The Landings, Ford Airfield

Phase RM4 (South)

Waste Infrastructure Technical Note

Report Ref: 2205771-R26

Figure 2: Noise levels due to Operations at the Grundon Site (Application Reference: WSCC/096/13/F and WSCC/027/18/F)

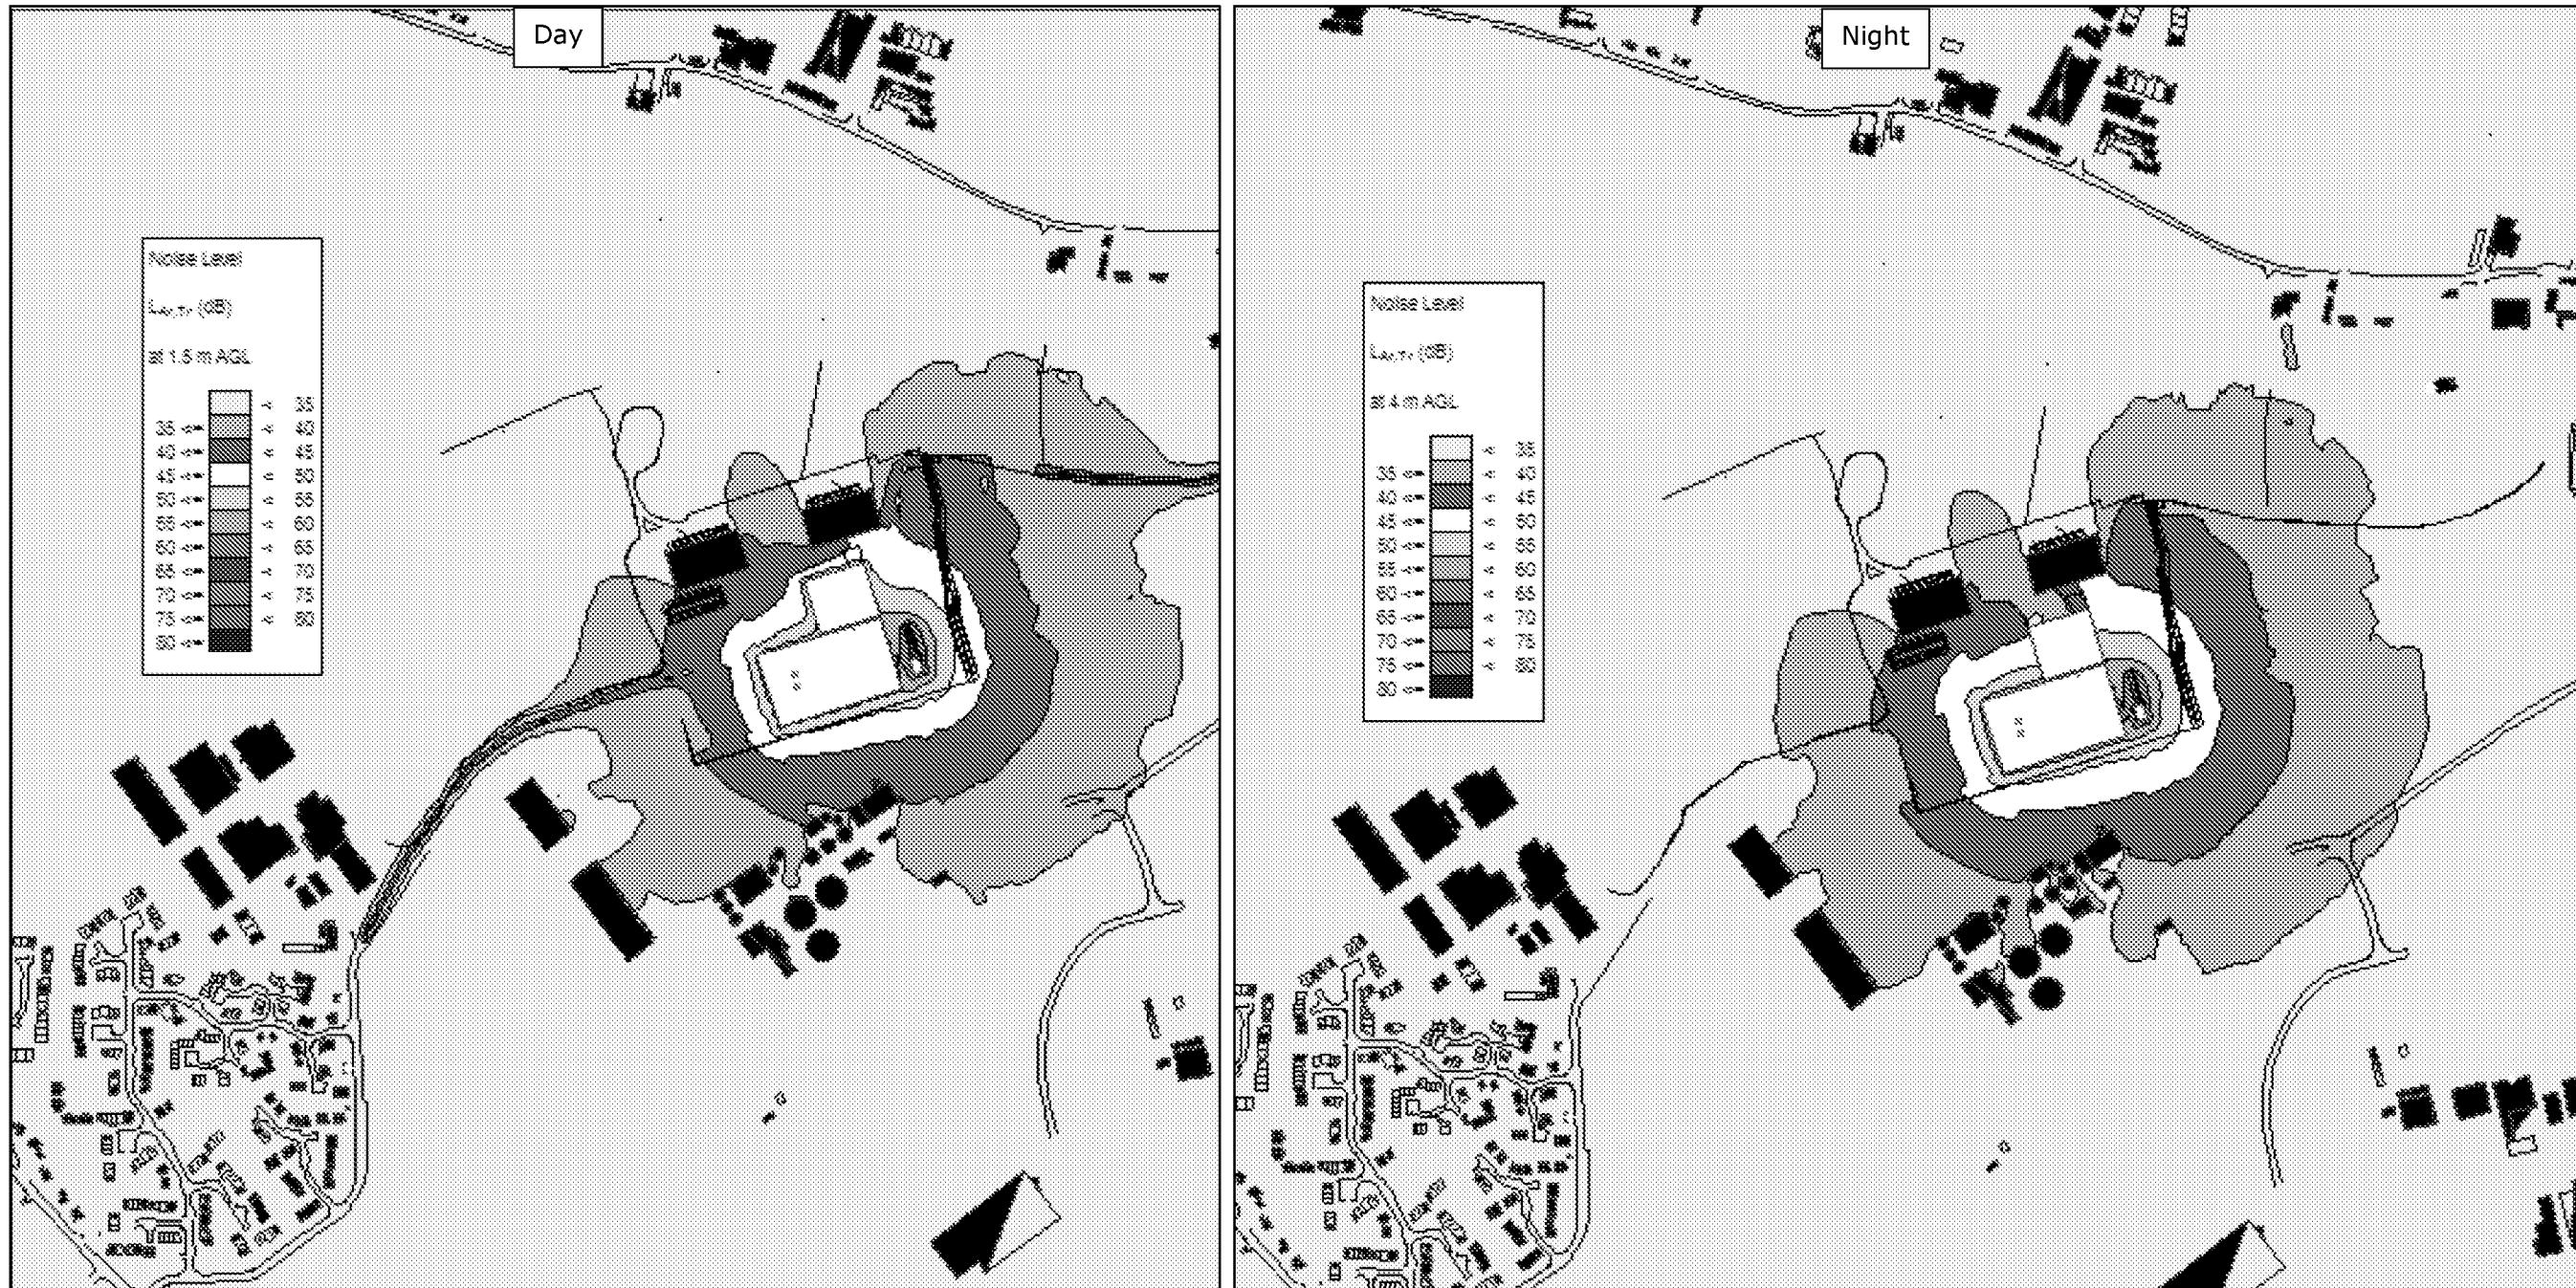
- 2.5. WSCC noted that the noise assessment does not demonstrate that noise from the Circular Technology Park/Grundon Waste Facility (Grundon) will meet the requirements of Condition 28 of the planning application for the facility, i.e., a rating level no greater than 35dB at the nearest sensitive receptors.

- WSCC/096/13/F: Circular Technology Park;
 - WSCC/027/18/F: Circular Technology Park;
 - WSCC/026/16/F: Wicks Farm;
 - WSCC/019/17/F: Wicks Farm;
- 2.7. The comments also note that noise levels from HD White (Ford Industrial Estate) would exceed the requirements of Condition 7, i.e. a rating level at the nearest sensitive receptors no greater than 5dB below the representative background sound level.

2.11. When a 3dB acoustic feature correction for impulsivity is applied to the noise levels at the nearest dwellings, the rating level due to operations at HD White will be 25dB $L_{Ar,Tr}$, which equates to 14dB below the representative background sound level. When a 3dB acoustic feature correction for impulsivity is applied to the noise levels at the nearest dwellings, the rating level noise level due to operations at Grundon will be 34dB $L_{Ar,Tr}$.

2.12. The noise assessment which accompanied the planning application for the Grundon Site shows the modelled noise levels with the proposed future operations, an extract from the noise modelling is shown below in Figure 2. Based on the noise modelling, noise levels are predicted to be significantly below 35dB $L_{Ar,Tr}$ at RM1 (North).

Figure 6: Proposed 4m High Noise Barrier Locations and Landscaping

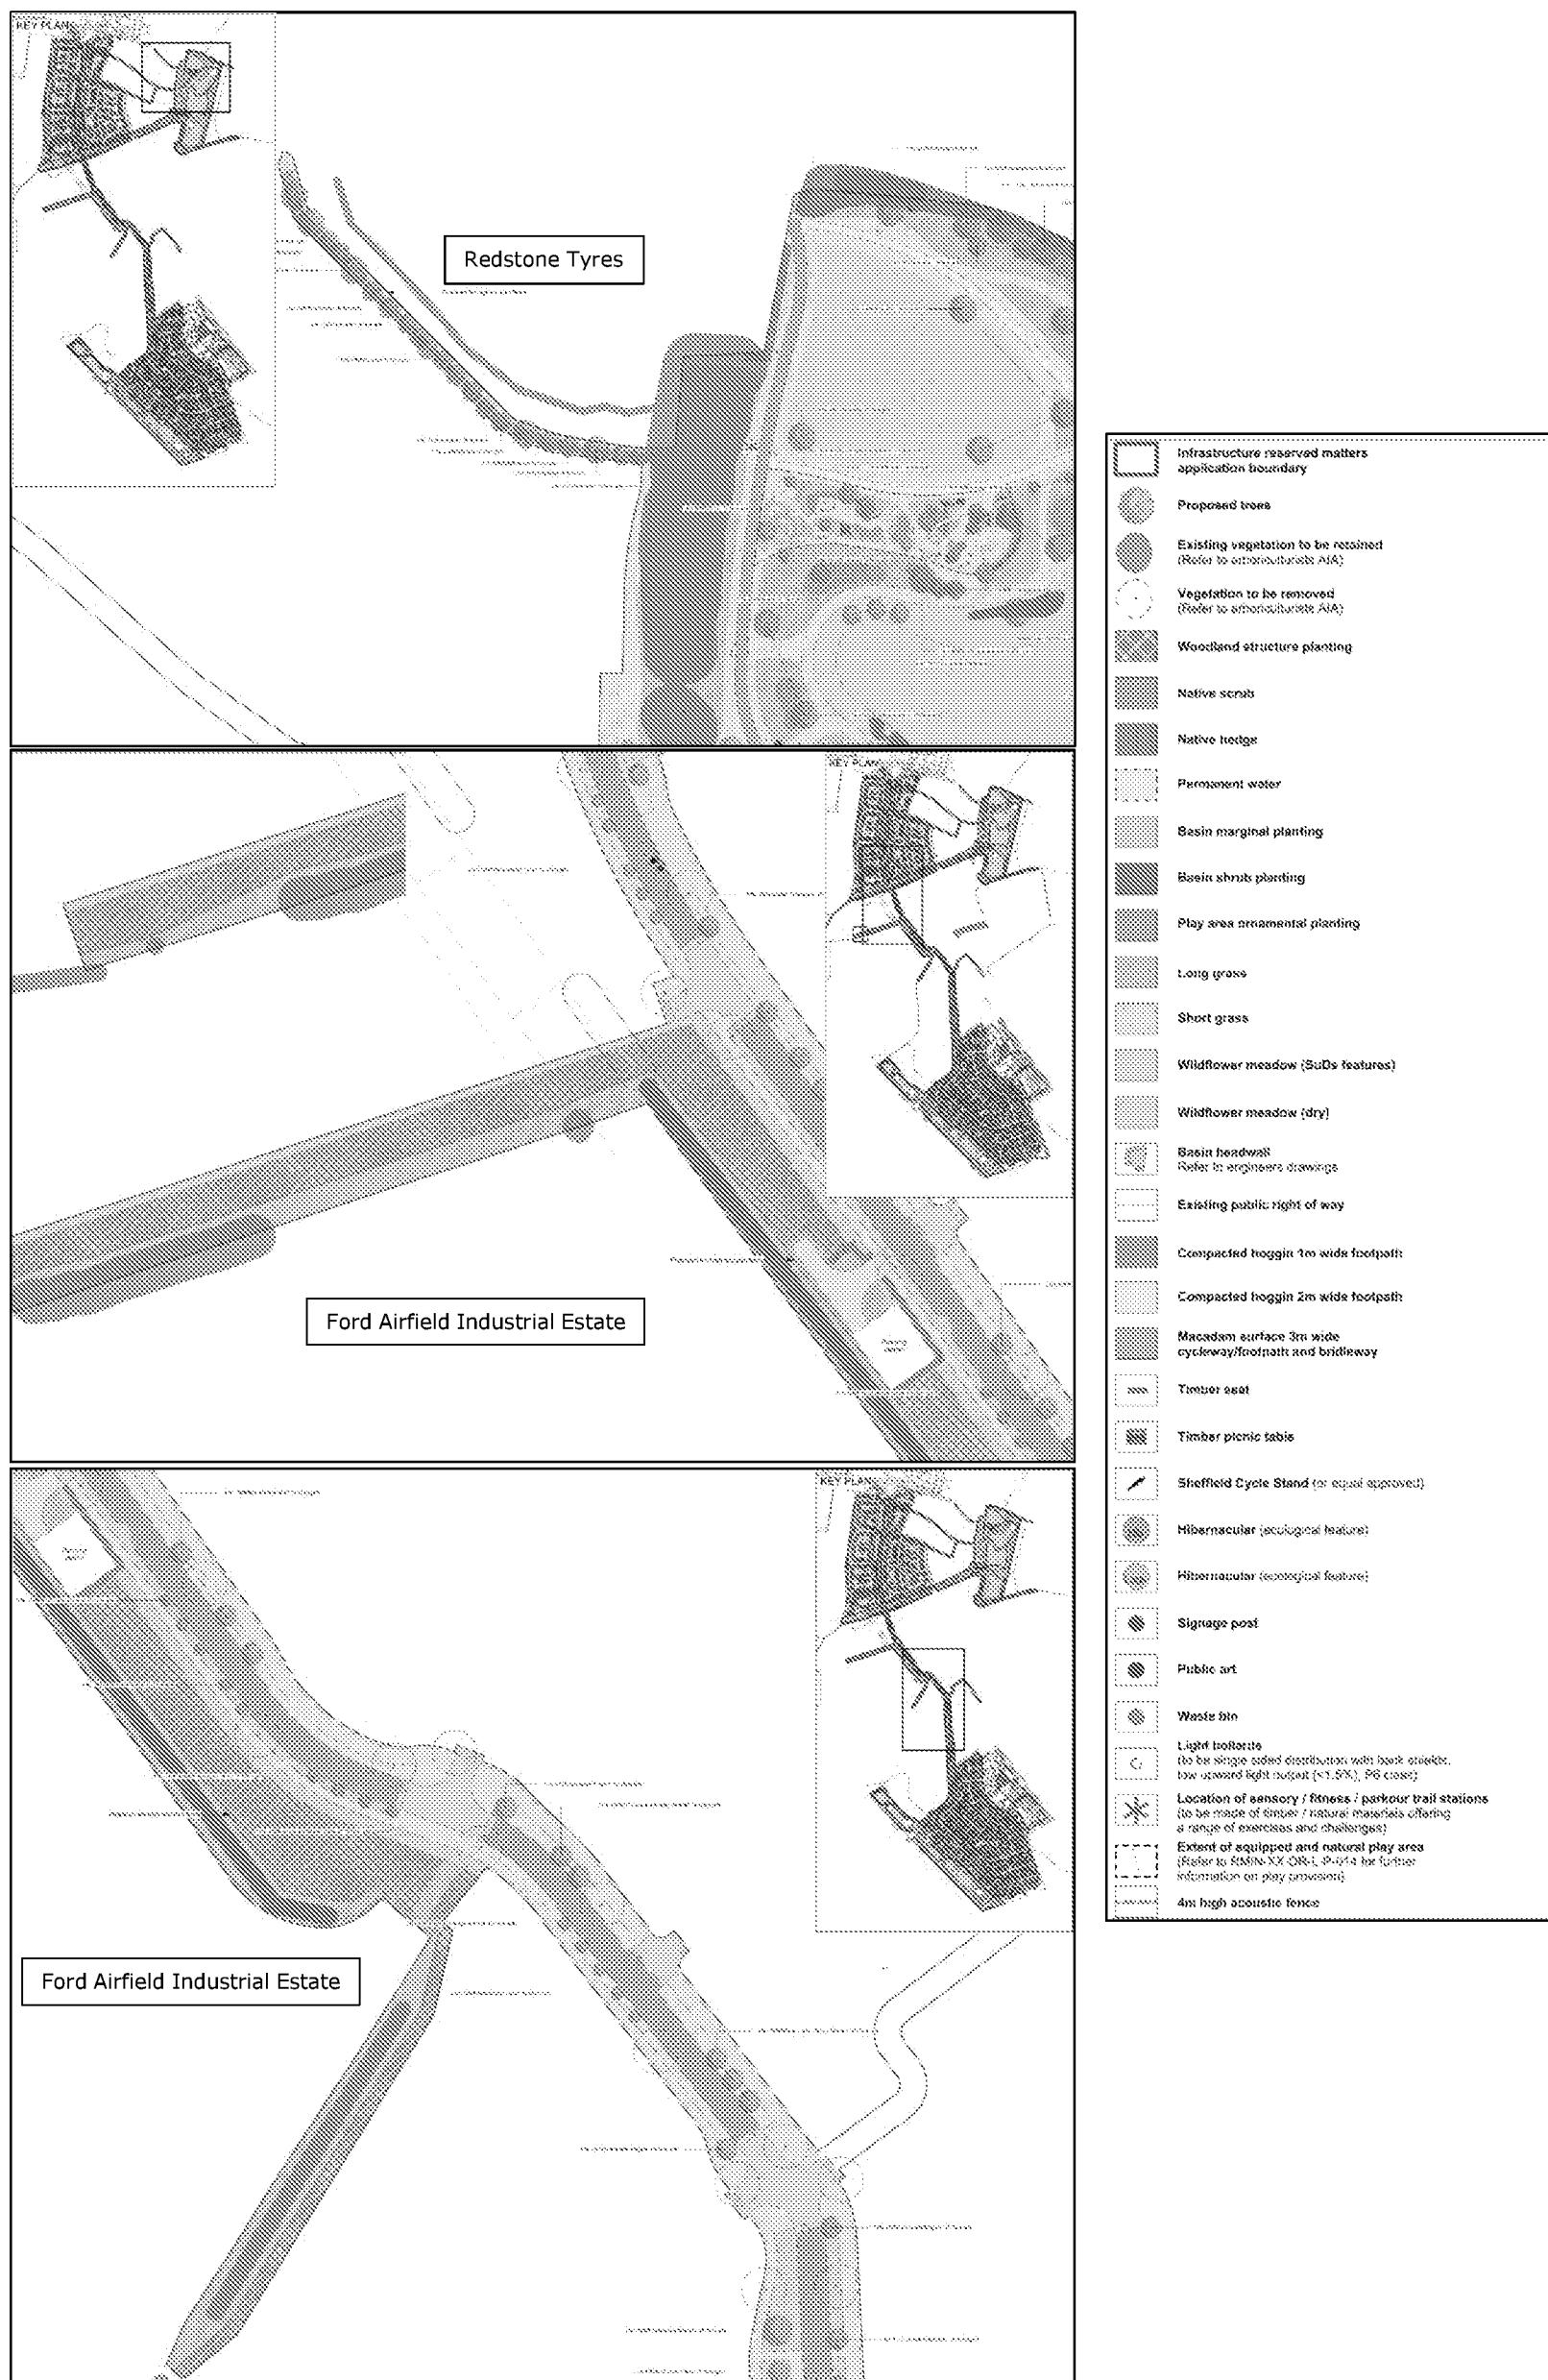
4.15. Noting WSCC comments in relation to the potential break to visual screening introduced by the location of the pumping station along the Spine Road, a small section of H1012 C (Hawthorne) will be removed and planted with a similar evergreen/deciduous woodland mix that blends with the proposed woodland structural planting to the north and south of the pumping station.

- 4.4. The locations of the 4m high noise barriers are shown in the primary street drawings which accompany the infrastructure Reserved Matters planning application. Structural woodland planting, basin shrub planting and trees are proposed, which will reduce the visual impact of the barriers. An extract of the drawings is shown in Figure 6.

4.5. A number of heights have been tested and the results of the noise modelling identify that a barrier height of 4m provides the best possible reduction in noise levels, whilst also taking into account other design considerations, such as landscaping and arboriculture. Taller structures would provide little additional acoustic benefit and would have an increased visual impact.
